Project	IEEE 802.16 Broadband Wireless Access Working Group < http://ieee802.org/16 >	
Title	Proposal to allow Extended Type subheaders for connections where ARQ is not enabled	
Date Submitted	2004-04-15	
Source(s)	Rehan Jalil Tassos Michail Mano Vafai Aperto Networks 1637 S. Main St., Milpitas, CA 95035, USA	Voice: + 1-408-719-9977 Fax: + 1-408-719-9970 mailto:rjalil@apertonet.com mailto:tmichail@apertonet.com mailto:mvafai@apertonet.com
Re:	802.16REVd/D4 Sponsor Ballot	
Abstract	The document proposes to allow the use of extended subheader type for connections where ARQ is not enabled.	
Purpose	To adopt the proposed changes during comment resolution procedure for sponsor ballot recirculation of 802.16-REVd/D4.	
Notice	This document has been prepared to assist IEEE 802.16. It is offered as a basis for discussion and is not binding on the contributing individual(s) or organization(s). The material in this document is subject to change in form and content after further study. The contributor(s) reserve(s) the right to add, amend or withdraw material contained herein.

Proposal to allow Extended Type subheaders for connections where ARQ is not enabled

*Rehan Jalil, Tassos Michail, Ma

Figure 1: Example of incorrect reassembly for non-ARQ connection using 3-bit FSN

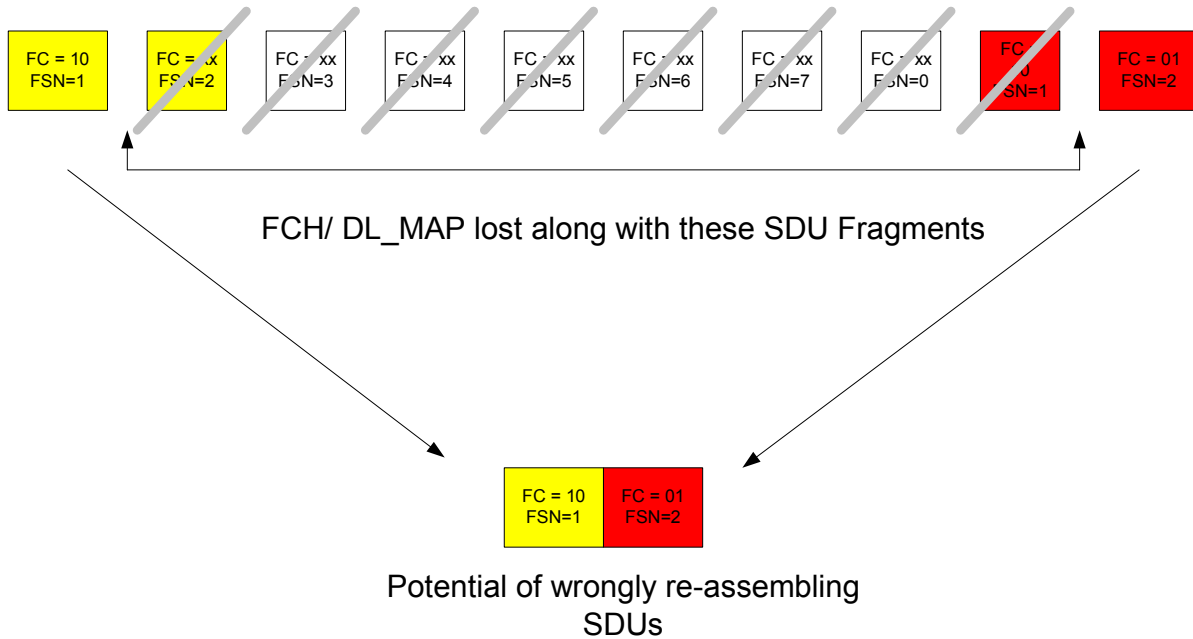
We next illustrate with an example how incorrect reassembly of an SDU may occur if a 3-bit FSN is used. In the scenario shown in Figure 1, 8 consecutive fragments are lost due to a lost FCH/DL-MAP and as a result the FSN wraps-around and causes incorrect reassembly. Given that Ethernet frames do not have CRC, such errors would cause significant performance degradation of upper layer protocols (such as TCP, UDP etc).
